CITY OF ALBUQUERQUE

**RE: MDS - Montage Subdivision Unit 7 on Bobby Foster
Grading and Drainage Submittal for Preliminary Plat and Grading Permit
Grading Plan Engineer's Stamp Date: 3/5/2023
Drainage Report Engineer's Stamp Date: 3/6/2023
Hydrology File: R16D100A**

**RE: MDS – Montage Subdivision Unit 7 on Bobby Foster
Grading and Drainage Submittal for Preliminary Plat and Grading Permit
Hydrology File: R16D100A**

Design Review Committee	City Engineer	Mo./Day/Yr.	Mo./Day/Yr.
City Project No.	Zone Map No.	Sheet	Of
775685	R-15-Z, S-15-Z	4	11

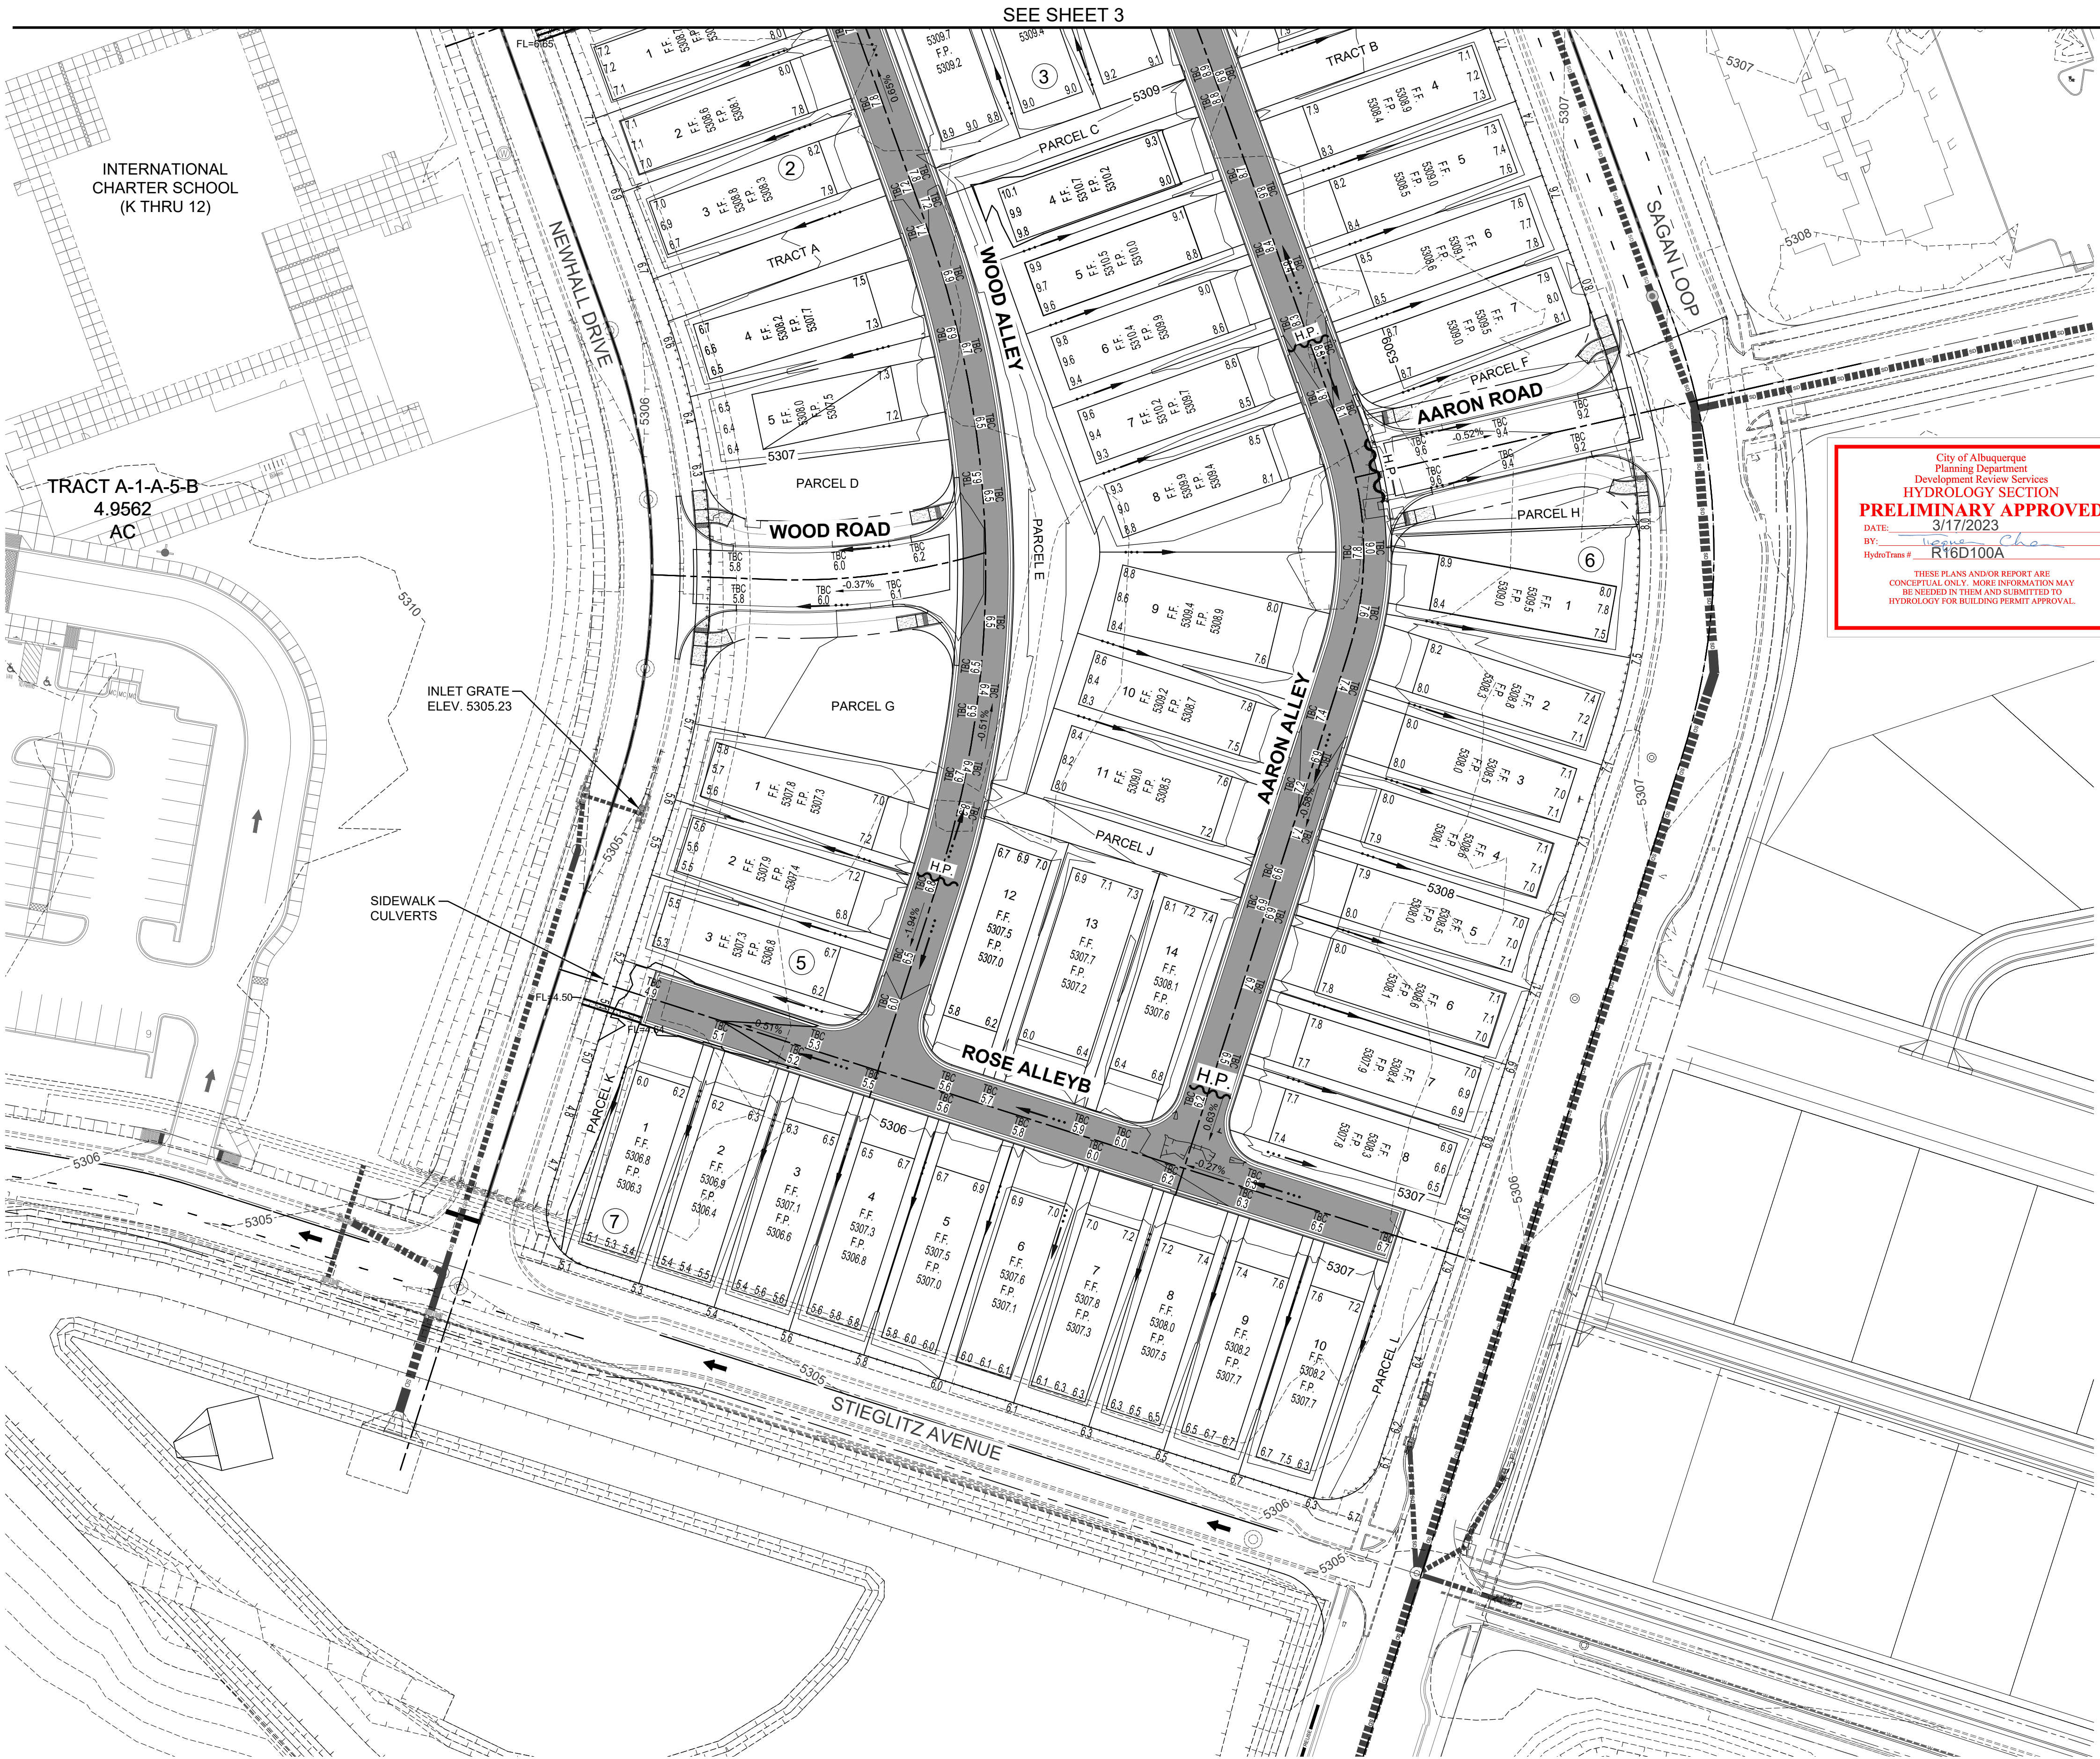
1. Add existing SD and proposed SD on to the legend.
2. Sheet 3, Hopper Alley to Newhall Drive: Add "3-24 inch" to the "Sidewalk Culverts" build note.
3. Sheet 4, Rose Alley to Newhall Drive: Add "1-24 inch" to the "Sidewalk Culvert" build note.
4. Add SO-19 notes. (Attached)

Design Review Committee	City Engineer	Last Update	Mo./Day/Yr.	Mo./Day/Yr.
City Project No. 775685	Zone Map No. R-15-Z, S-15-Z		Sheet 9	Of 11

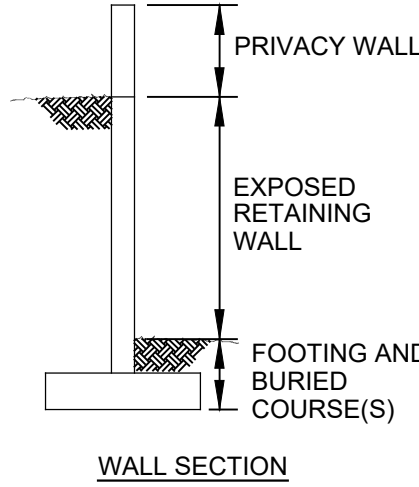
- i. Add a typical lot grading detail with typical section through the side yards at the front corner of the houses. The plan should clearly indicate which portions of each lot drains to the alley and to the street.

Typical lot grading detail included on sheet 9.
